# Access Compliance Report

## Public Rights-of-Way

Intersection ID: 27418	Main Street: BALLANTYNE COMMONS PY	Cross Street: BALLANTYNE TRACE CT	Location: SE
ADA ID: E672DD47D747	Ramp Type: Perp	Initial Pass/Fail: Fail	Overall Compliance: No
Severity Score: 22.5			
Codes/Mitigation Info/Possible Solution		Field Measurements/Component Compliance

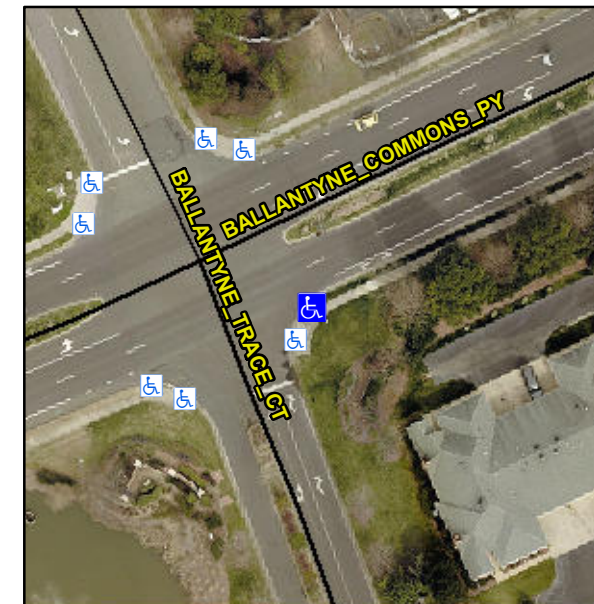
**Not Found, R304.5.1, R304.2.2**

Compliance	Description	Data	Compliance	Description	Data
N/A	Ramp Length (in)	107.0	No	Ramp Slope (%)	9.9
No	Ramp Width (in)	37.0	Yes	Ramp XSlope (%)	3.6
N/A	Flare Type LT	N/A	N/A	Flare Type RT	N/A
N/A	Flare Slope LT (%)	N/A	N/A	Flare Slope RT (%)	N/A
N/A	Flare Traversable LT?	N/A	N/A	Flare Traversable RT?	N/A
N/A	Landing Length (in)	N/A	N/A	DWS Provided?	N/A
N/A	Landing Width (in)	N/A	N/A	DWS Contrast?	N/A
N/A	Landing Slope (%)	N/A	N/A	DWS Length (in)	N/A
N/A	Landing X Slope (%)	N/A	N/A	DWS Full Width?	N/A
N/A	Landing Curb? (Y/N)	N/A	N/A	DWS Offset (in)	N/A
N/A	Shared Landing?	N/A			
N/A	Gutter Ponding?	N/A	N/A	Gutter Slope (%)	N/A
N/A	Gutter Lip Ht (in)	N/A	N/A	Gutter X Slope (%)	N/A
N/A	Painted X Walk1?	No	N/A	Painted X Walk2?	N/A
	X Walk 1 Direction	To N		X Walk 2 Direction	N/A
N/A	X Walk 1 Width (in)	N/A	N/A	X Walk 2 Width (in)	N/A
	X Walk 1 Slope (%)	0.6		X Walk 2 Slope (%)	N/A
	X Walk 1 X Slope (%)	4.6		X Walk 2 X Slope (%)	N/A

**Remove & Replace Entire Ramp.**
